# UNITED STATES PATENT AND TRADEMARK OFFICE

10/522,210

Herve Riu

**Office Action Summary**

Taken from Riu Figure 1

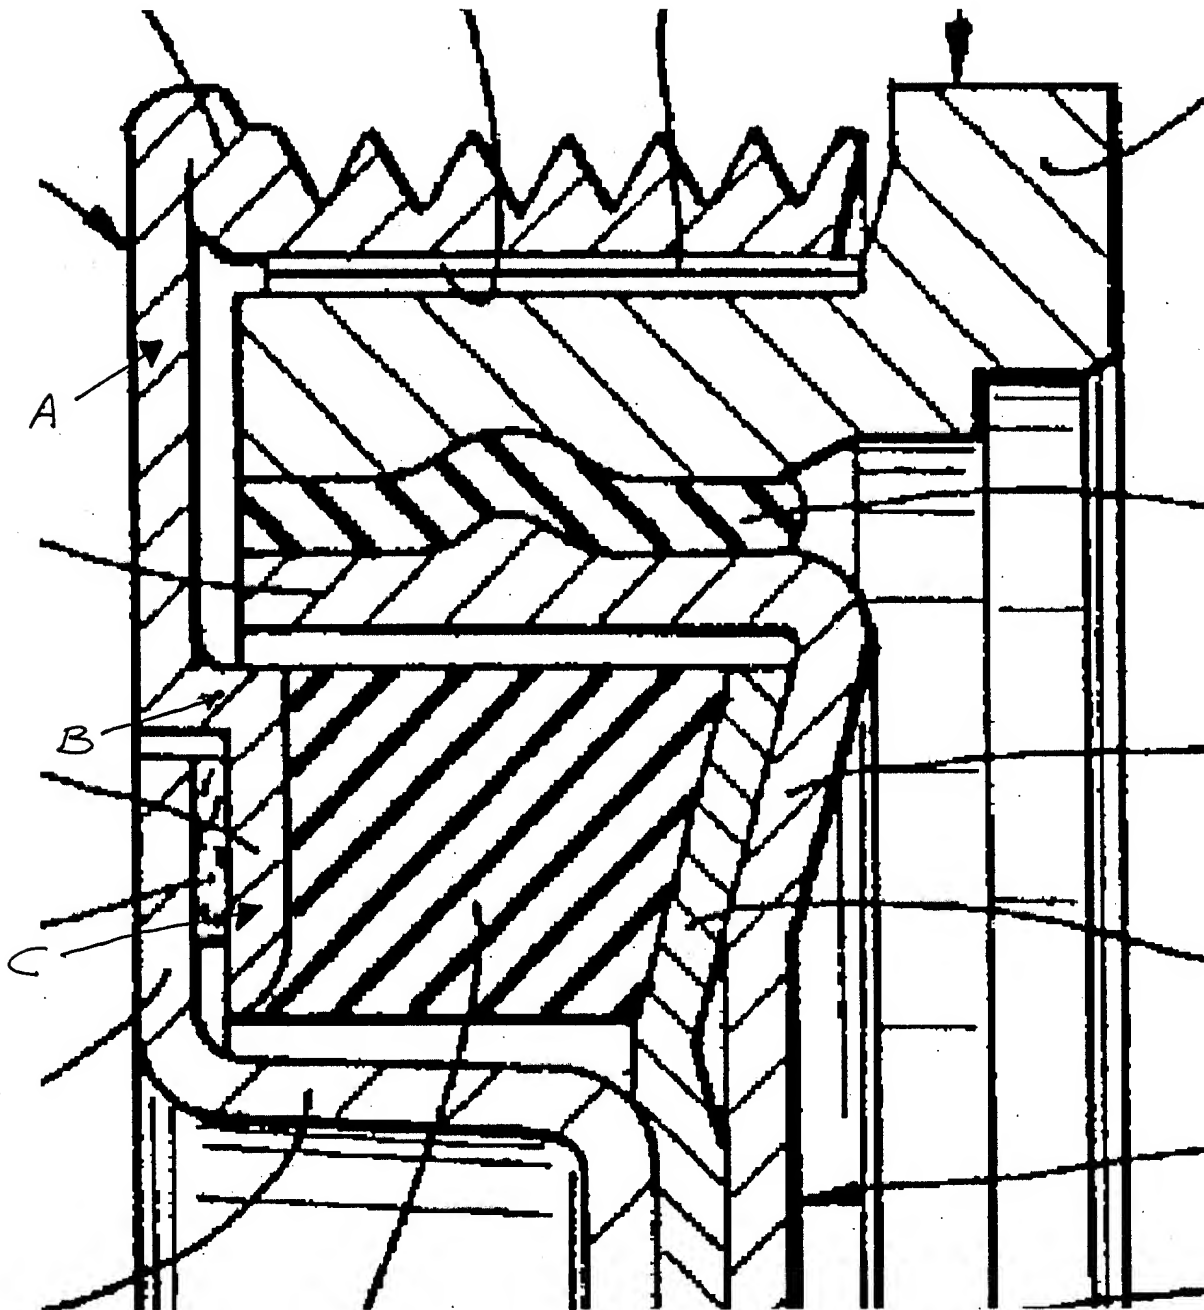
Riu discloses an integrated pulley-torsional damper assembly including:

- A hub (11)
- A drive member (at axis 20)
- A pulley (21) connected to the hub (11, via 24 and 25)
- A first elastomeric ring (24)
- A inertia ring (19)
- A second elastomeric ring (14)
- Said hub comprising:
  - An internal annular flange (16)

- An annular coupling portion (12) having a substantially C-shaped cross section
  - A cavity (houses 23, 24 and 25)
  - An outer tubular wall (13) on which said second elastomeric ring (14) is fitted

- A bearing (40) set between the outer tubular wall (13) and the pulley (21)
- Said pulley comprising:
  - A peripheral crown (22)
  - A flange (23/33) extending radially inwards from said crown (22)

- Said flange (23) comprising:
    - An outer annular portion (A, see Figure below)
    - An intermediate tubular wall (B) coaxial with respect to the crown (22)

- An inner annular flange (C) extending [radially] inward from said tubular wall (B) opposite the outer annular portion (A) and facing the peripheral edge (25) of the coupling flange (29)

- A coupling flange (29) provided with an inner annular wall (26) bearing axially against said flange (16) of the hub (11) and with a peripheral annular edge (25)

- Said first elastomeric ring (24) being set axially between said inner annular flange (C) and the peripheral annular edge (25) and forming a single body (one pulley) with them
- Said inertia ring (19) being contained inside said crown (22)
- Said elastomeric ring (24) being housed within said cavity of said annular coupling portion (12)
